SS 284 eB2 (Jouley) Excessive Parasitic Draw & Road Speed Limit Adjustment Feature (576181)

PCM 4.3.1 Update for eB2

8/17/2023

Inverter Pin 1 (BATT) rework to Ignition switched power

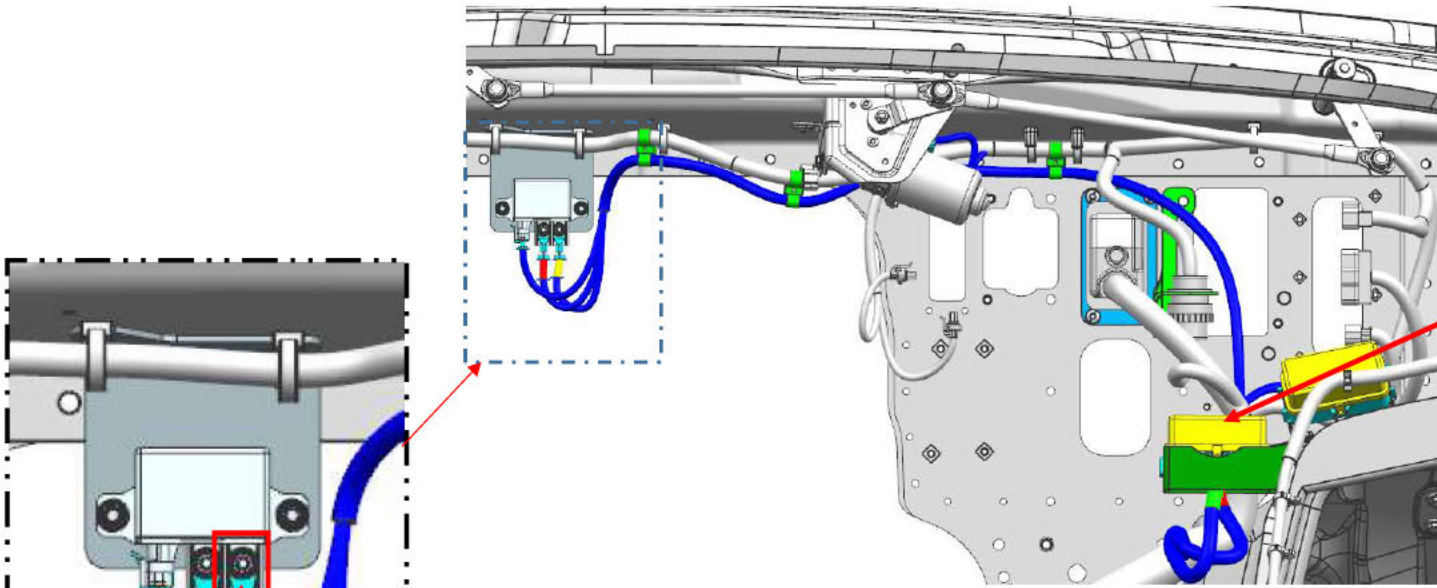
Inverter currently supplies constant battery power.

Battery draw = Re-wire battery constant source to ignition source. (See attachment)

Please ensure wiring is installed correctly at the high current relay as seen on the last page.

1. Create the wire below with terminals on both end.
2. Locate the powertrain PDM fuse holder.
3. Remove the circuit on E5. Tape the terminal so it does not short.
4. Insert the new wire to pin 5 and double stack the ring terminal to the high current relay terminal 3.
5. Zip the wire to the main bundle on the front wall.

16 GA (1650 mm)

To pin E5

Terminal for 60way PDM fuse holder

Double stack ring terminal to high current relay terminal 3

Ensure terminal 2 has 12V with ignition off and terminal 3 does not
